SOLICITATION AMENDMENT
MODIFICATION DE L'INVITATION

Title - Sujet REPAIR AND OVERHAUL SUPPORT SERVICE	
Solicitation No. - N° de l'invitation W8482-116492/A	Amendment No. - N° modif. 009
Client Reference No. - N° de référence du client W8482-116492	Date 2012-08-29
GETS Reference No. - N° de référence de SEAG PW-\$\$ML-002-22827	
File No. - N° de dossier 002ml.W8482-116492	CCC No./N° CCC - FMS No./N° VME
Solicitation Closes - L'invitation prend fin at - à 02:00 PM on - le 2012-09-24	
F.O.B. - F.A.B. Plant-Usine: <input checked="" type="checkbox"/> Destination: <input type="checkbox"/> Other-Autre: <input type="checkbox"/>	
Address Enquiries to: - Adresser toutes questions à: Wright, Muriel	Buyer Id - Id de l'acheteur 002ml
Telephone No. - N° de téléphone (819) 956-4886 ()	FAX No. - N° de FAX (819) 956-0897
Destination - of Goods, Services, and Construction: Destination - des biens, services et construction:

SOLICITATION AMENDMENT 009 IS ISSUED TO DISTRIBUTE THE SEVENTH (7th) SET OF QUESTIONS AND ANSWERS TO ALL BIDDERS AND TO EXTEND THE BID CLOSING DATE TO 24 SEPTEMBER 2012.

STUFFING BOX REQUIREMENTS

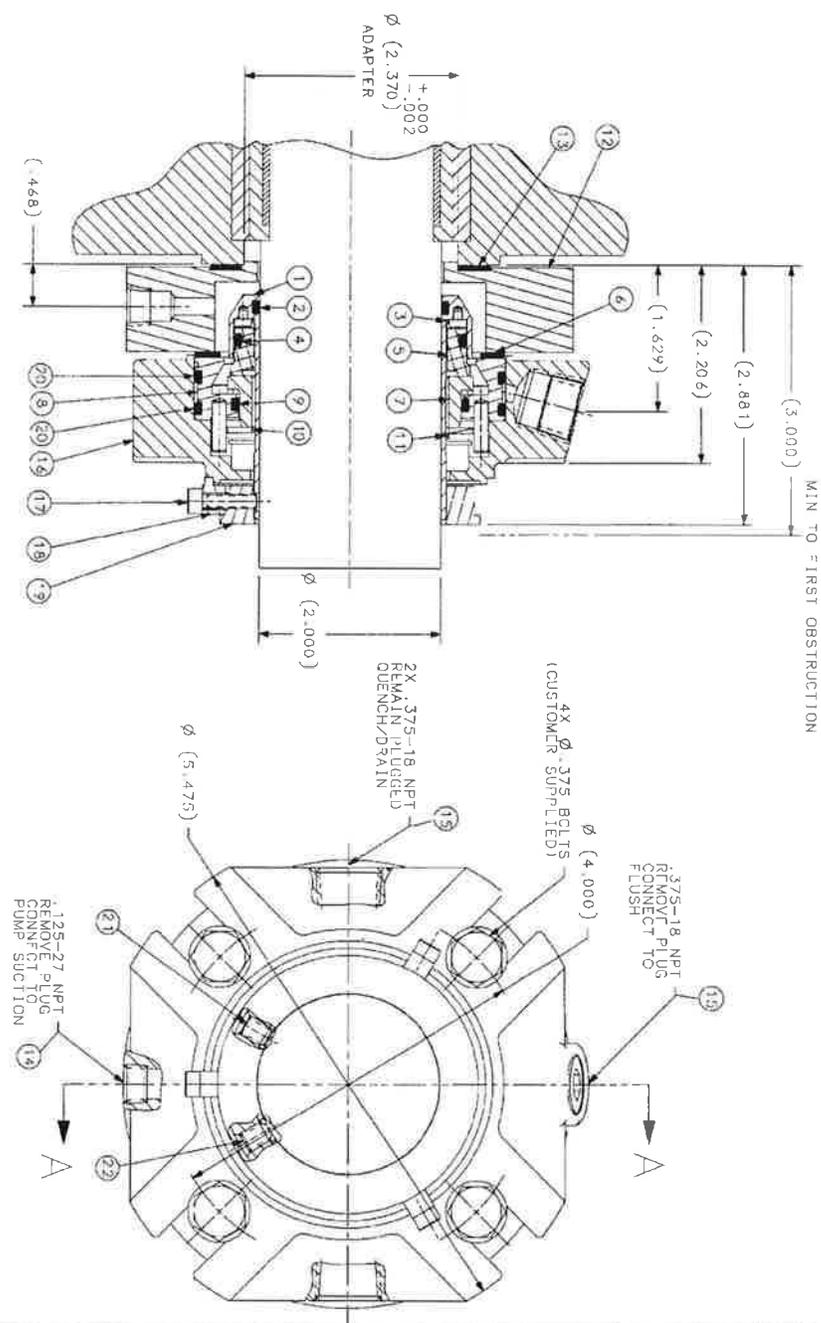
Amendment 6, Answer 4 referenced two drawings, only one of which was included with that Amendment. Amendment 7, Answer 1 attempted to correct the oversight by including the second drawing in that Amendment. However, the drawing omitted from Amendment 6 was also omitted from Amendment 7.

Could you please ensure the drawing in question is made available to all bidders?

Please see attached drawing.
